Potential Risks to Water Resources from the Proposed Thabametsi Power Plant

Evan Hansen

March 2, 2018

Figure 2: Faults in the immediate vicinity of the coal ash dump and pollution control dams

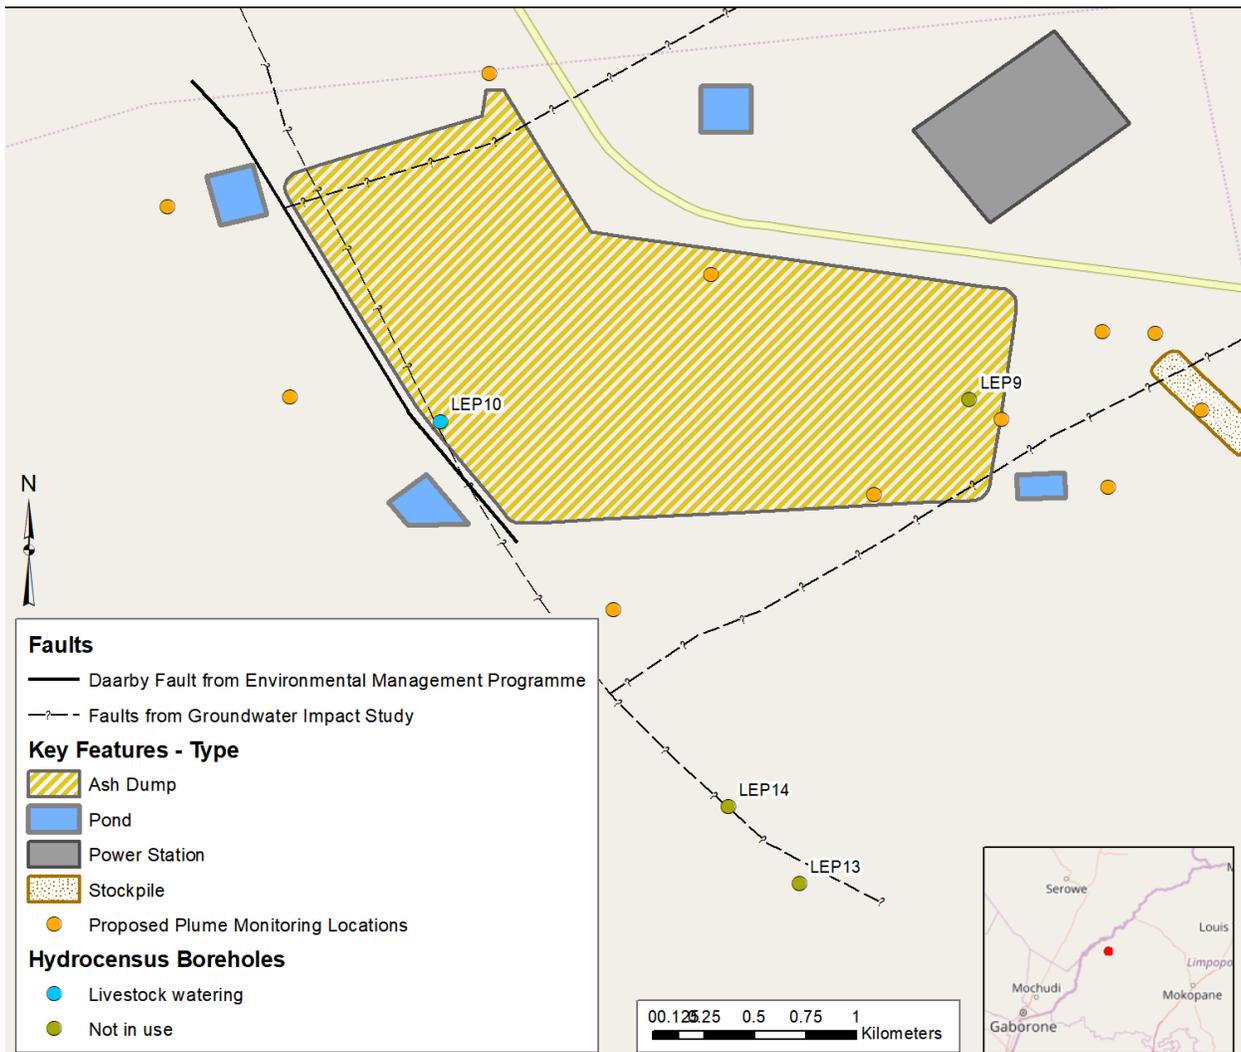
The applicant's Layout Plan maps the north-south trending Daarby Faultline, which is in between the western edge of the proposed coal ash dump and the eastern edge of two of the three PCDs, including the PCD proposed to be built first. The faultline is within approximately 100 meters of the dump and the PCDs. (Thabametsi Environmental Management Programme) Figure 2 maps the Daarby Faultline from the Environmental Management Programme's Layout Plan as a thick black line.

While it maps the Daarby Fault, the Layout Plan ignores the two east-west trending faultlines, which are described by the applicant as underlying the proposed ash dump. These faultlines are illustrated in a more general geological map of the area (Groundwater Impact Study). Figure 2 maps the faultlines from the Groundwater Impact Study as thinner dashed lines. Overlaying these maps illustrates that the east-west faultlines do, in fact, appear to underlie the proposed ash dump.

Further, the applicant’s omission of the east-west faults from the Layout Plan is an important omission. The Layout Plan should be revised to include the two east-west trending faults that underlie the proposed coal ash dump, and the applicant’s modeling of the potential pollution plume must include all nearby faults.

In addition to omitting important CCR-related parameters, the proposed groundwater monitoring program will not collect samples in the proper locations. As described by the applicant, the 16 existing boreholes will be used. As illustrated above in Figure 1, two of the 16 boreholes are under the proposed ash dump and presumably will not be available for monitoring (LEP9 and LEP10). None of the other 14 boreholes are located to the north or west of the proposed ash dump, even though the applicant’s own plume modeling shows that any leak of pollutants from the dump would generally travel toward the west.

To remedy this oversight, the applicant proposes a monitoring network extension; these 11 proposed monitoring wells are illustrated as orange circles in Figure 2. While these locations appropriately encircle the proposed ash dump, the extension of the monitoring system to include these wells is purely speculative:

The additional 11 proposed monitoring wells that encircle the proposed ash dump site should be definitively incorporated into the groundwater monitoring plan, rather than simply being proposed. Without monitoring locations to the west of the dump, which is the direction that a pollution plume is predicted to flow, any pollution emanating from the dump would not be found via the groundwater monitoring program. This would threaten the health of any local population in that direction that is dependent on groundwater.
